**TEXAS UTILITIES GENERATING COMPANY**  
SKYWAY TOWER • 400 NORTH OLIVE STREET, L.B. 81 • DALLAS, TEXAS 75201

SUBJECT: COMANCHE PEAK STEAM ELECTRIC STATION  
DOCKET NOS. 50-445 AND 50-446  
RESPONSE TO B. J. YOUNGBLOOD LETTER TO  
M. D. SPENCE DATED JULY 26, 1984,  
"Technical Evaluation Report Regarding  
Control of Heavy Loads (Phase II-NUREG-0612)  
for CPSES

CPSES RESPONSE TO JULY 26, 1984 NRC  
LETTER ON HANDLING OF HEAVY LOADS

FIGURE A-10

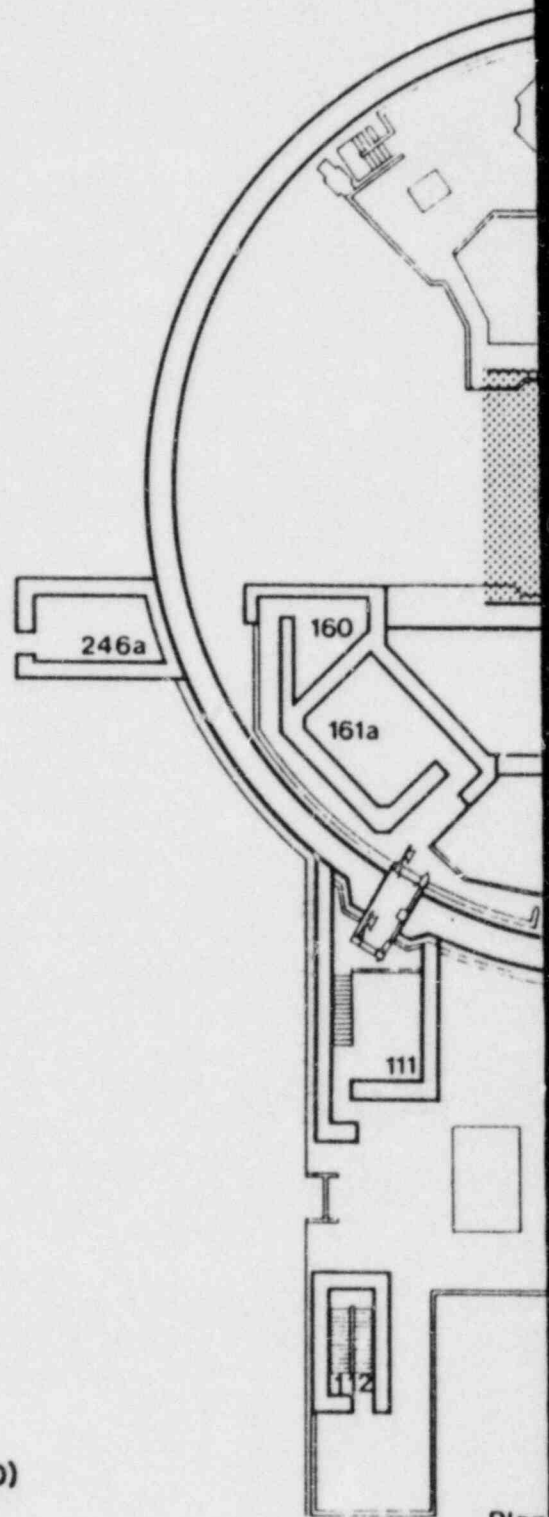
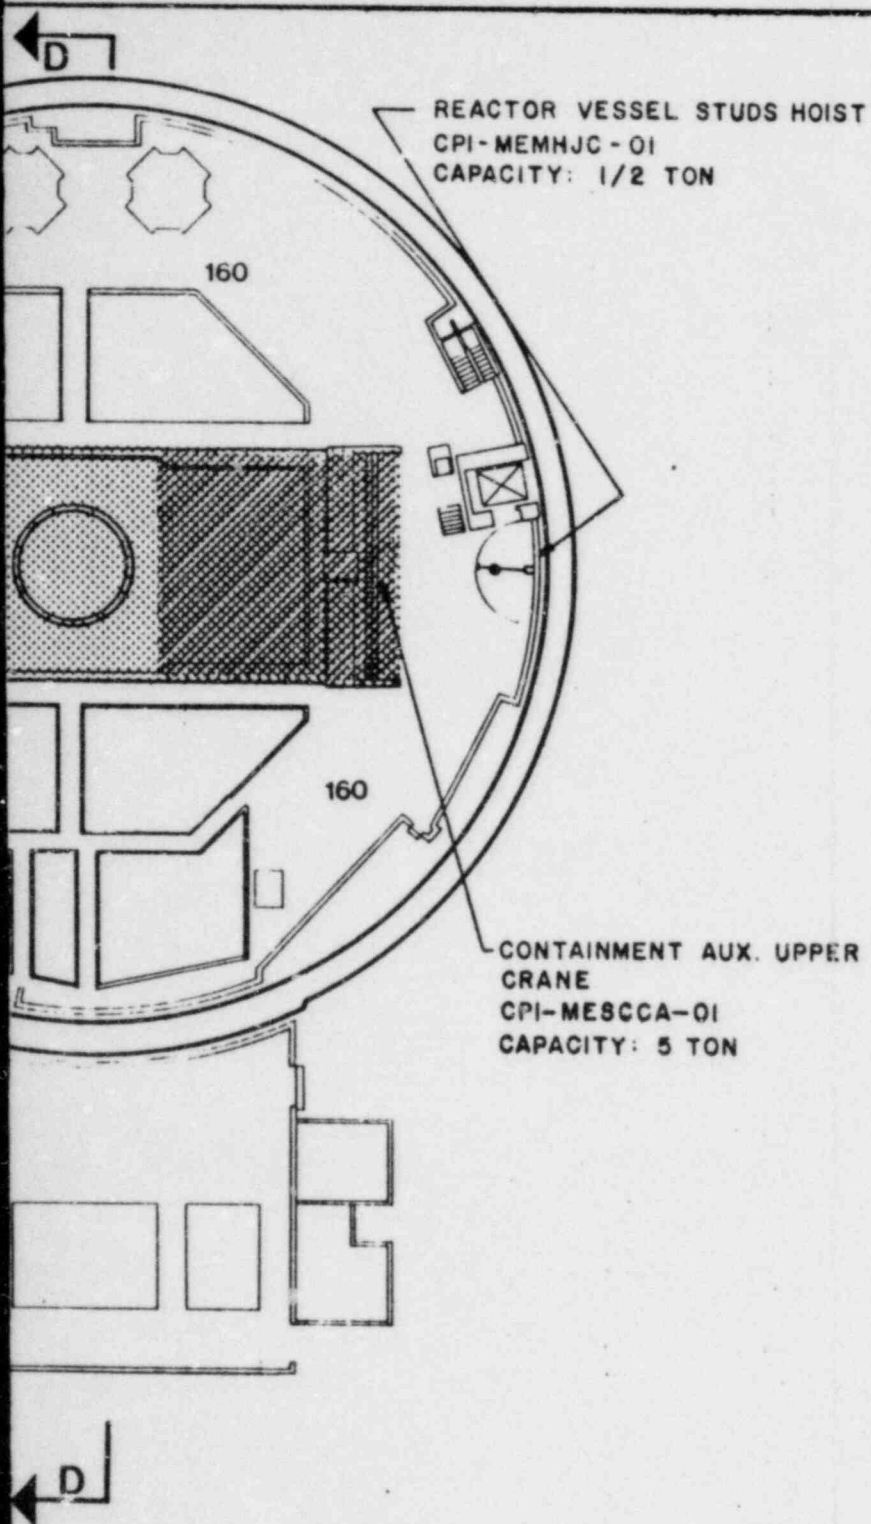
- (1) Heavy loads carried by the Containment Auxiliary Upper Crane and the Polar Crane Auxiliary Hoist shall not traverse an open reactor vessel as per Attachment A which provides updated figures from Reference 1.
- (2) CPSES does not arbitrarily exempt a load handling system from carrying heavy loads even though a heavy load has not been identified for that system. In the event that a heavy load is required to be handled by such a system, an engineering evaluation is made to consider which of the following is applicable to the system:
  - a) redundant shutdown and/or decay heat removal systems exist
  - b) load restrictions are necessary
  - c) single-failure-proof protection, administrative control and/or further engineering evaluation on postulated load drops is required.

FIGURE C-2

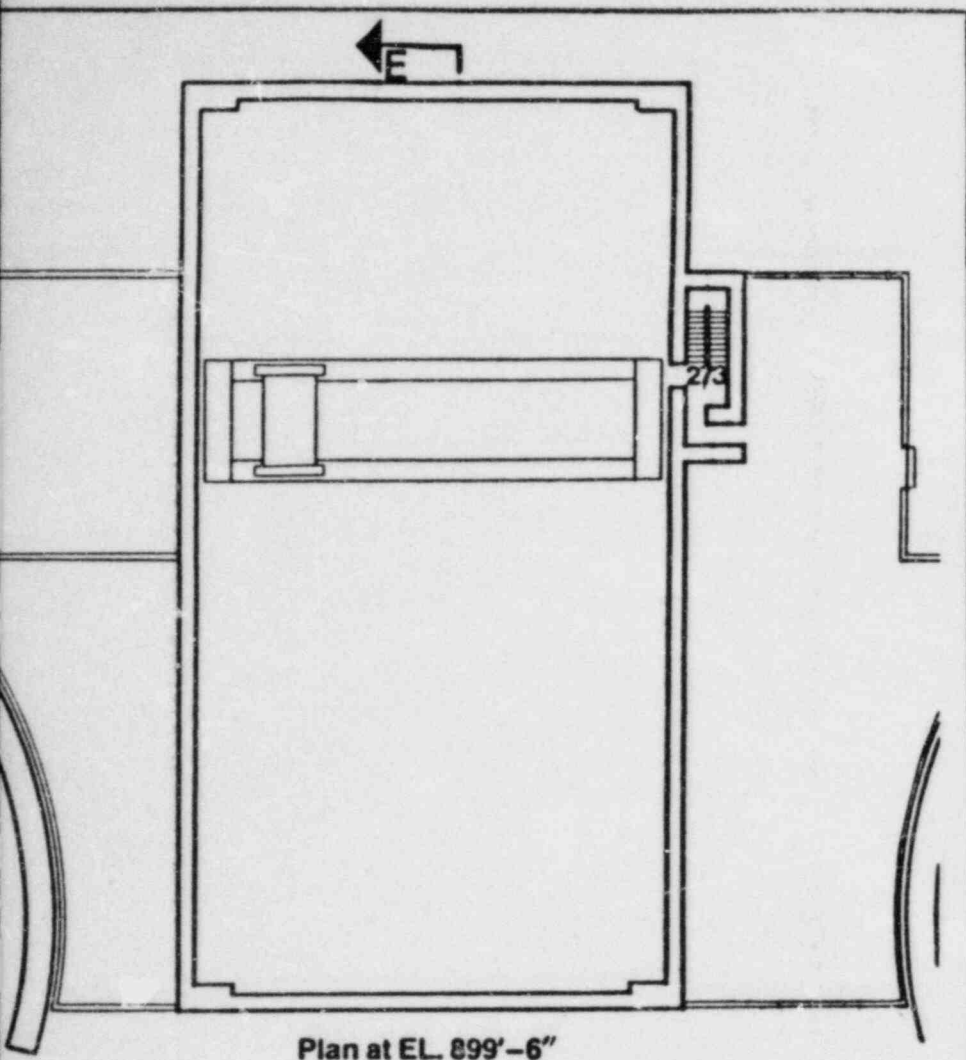
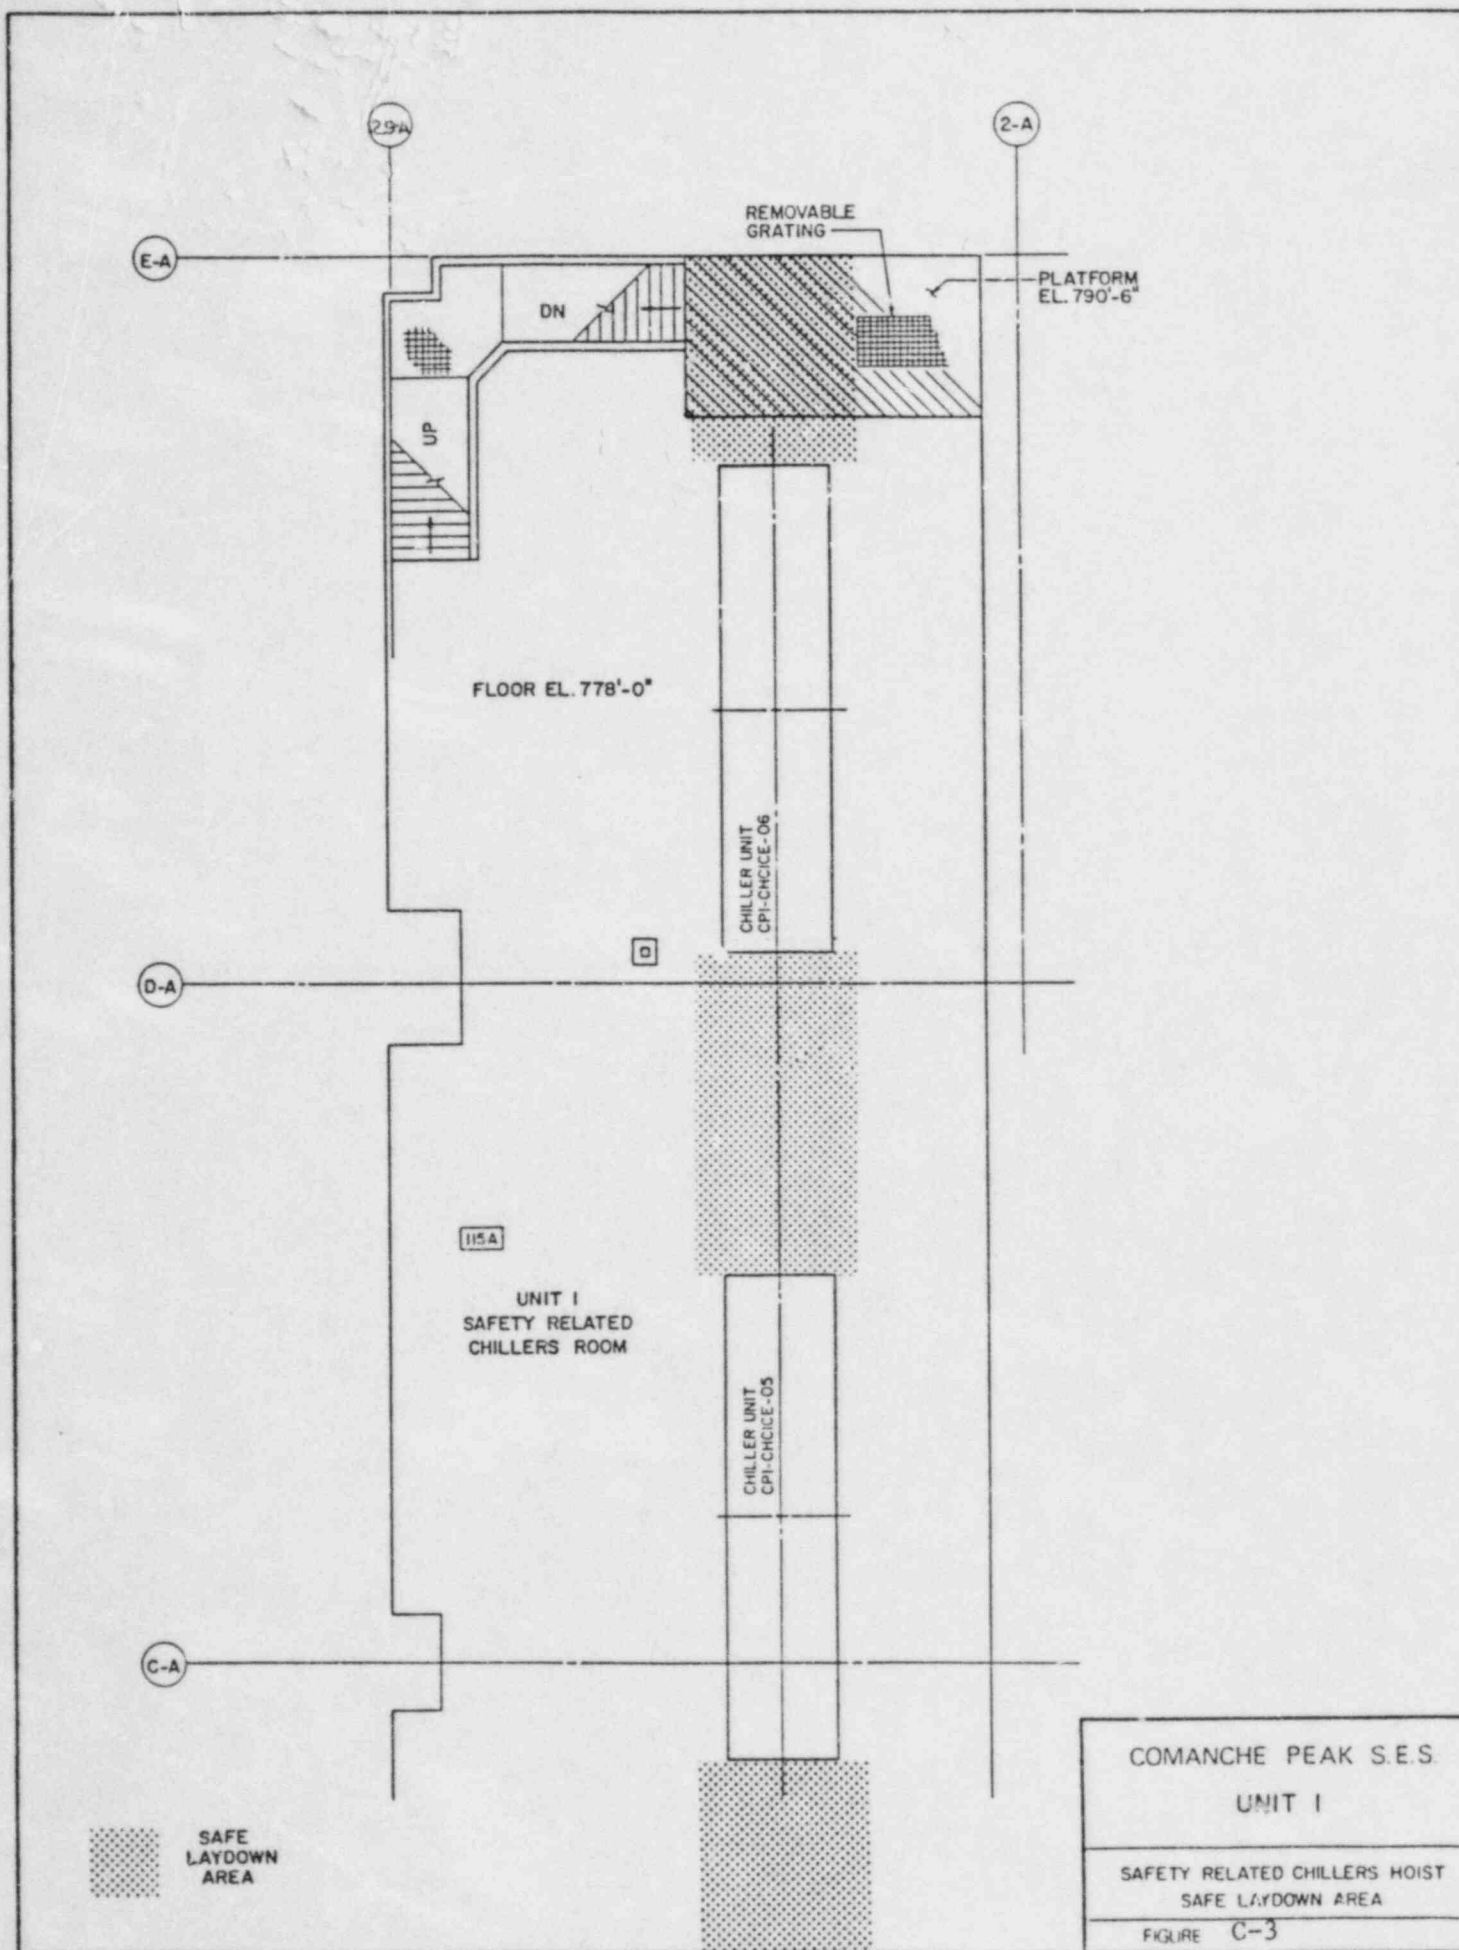
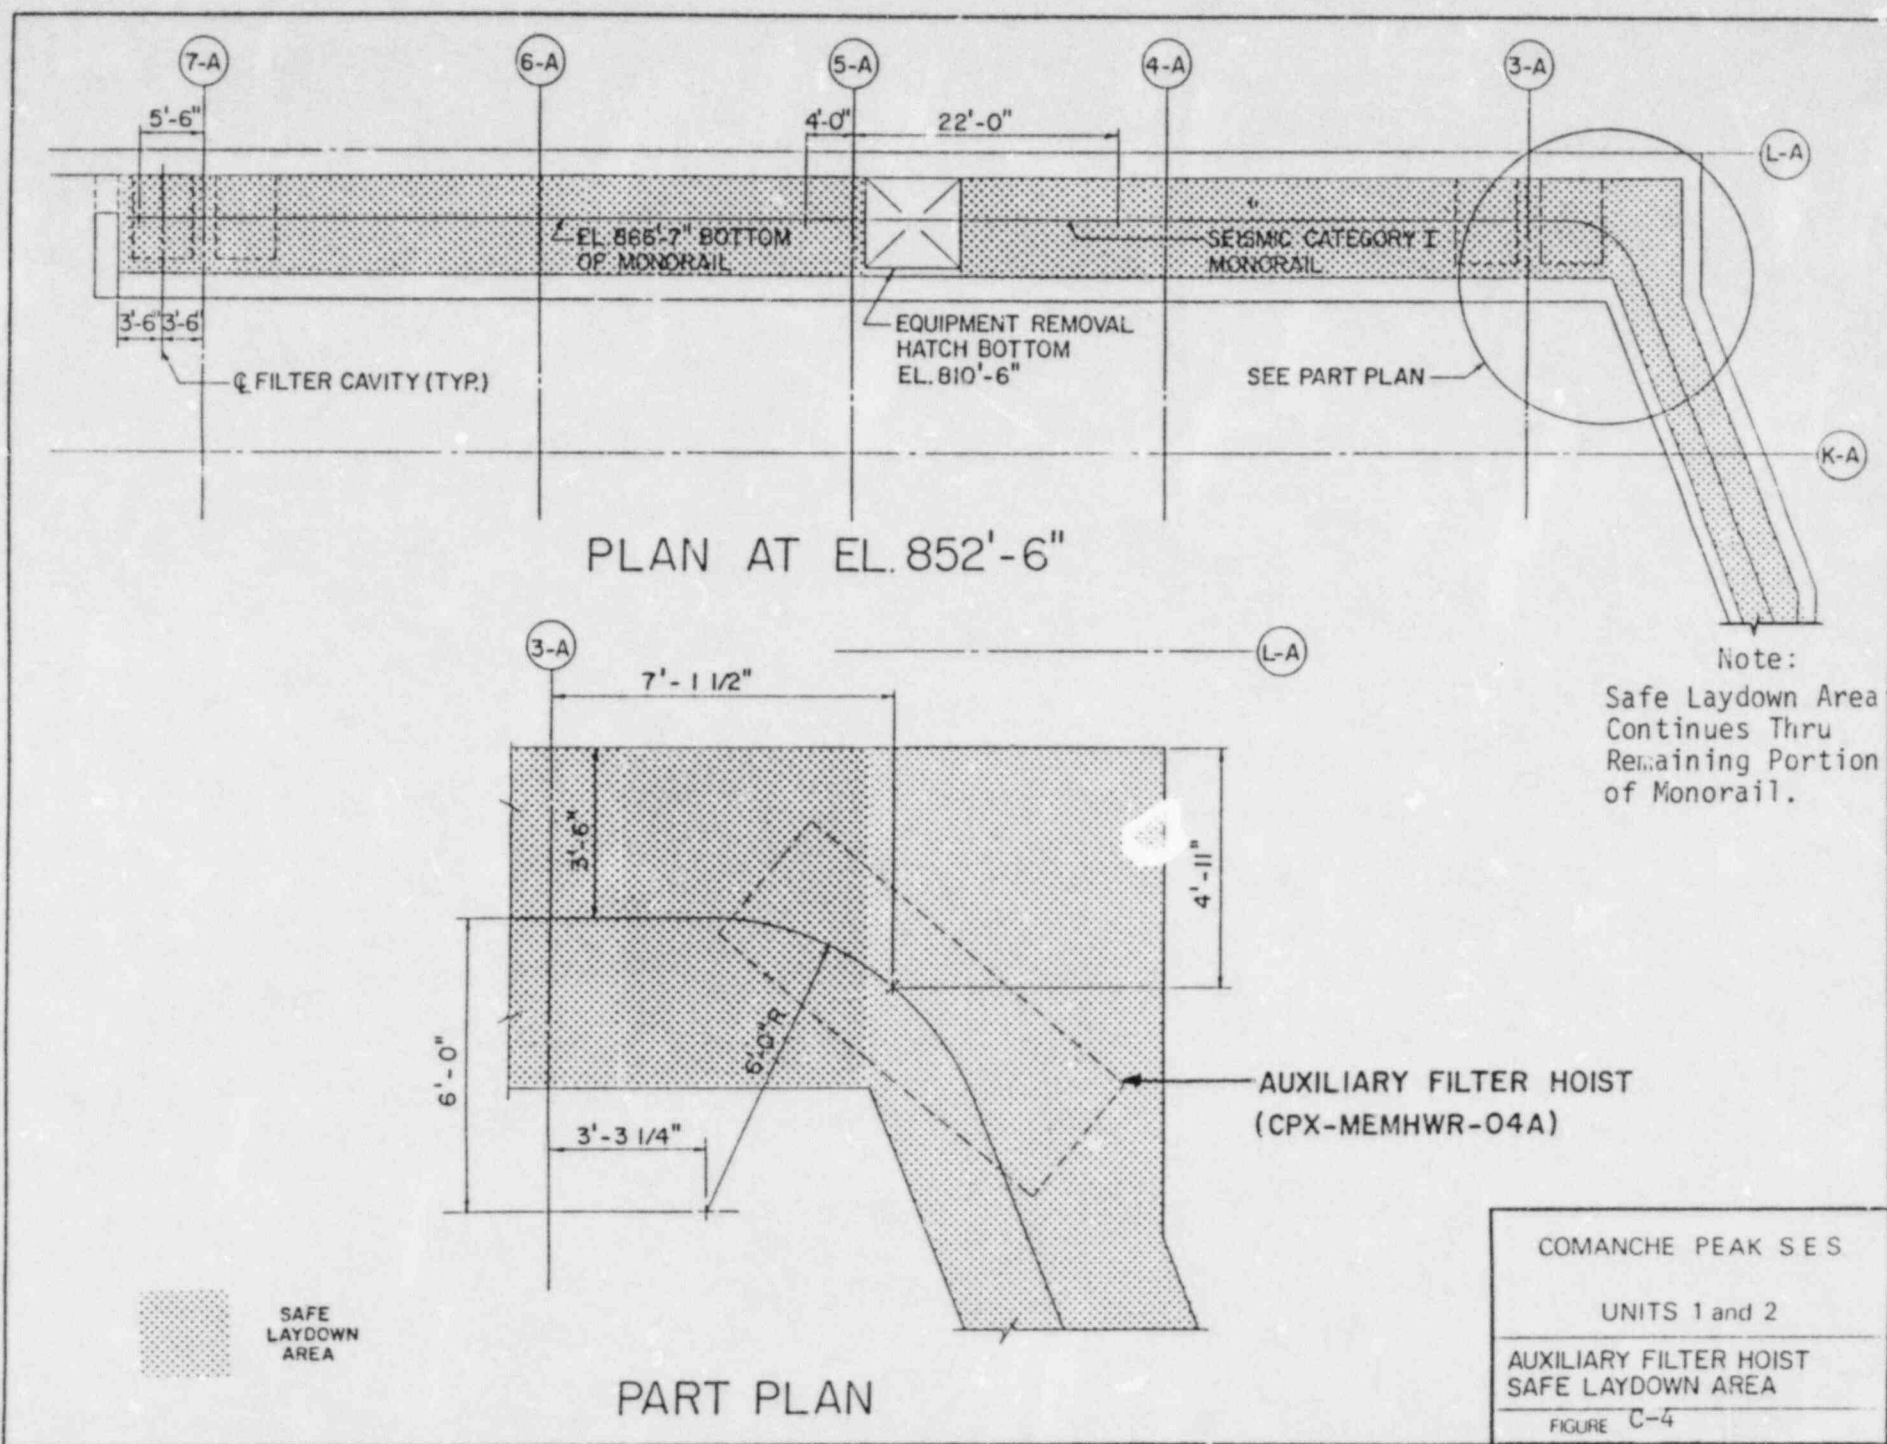
The auxiliary hoists of the Fuel Building Overhead Crane cannot physically travel any closer than 6' 3" from the nearest spent fuel pool. Heavy loads (> 2150 lbs.) handled within 15 feet of the spent fuel pools by the auxiliary hoists will maintain a load orientation such that the worst case postulated drop will not result in the load center of gravity extending past the edge of the spent fuel pools.
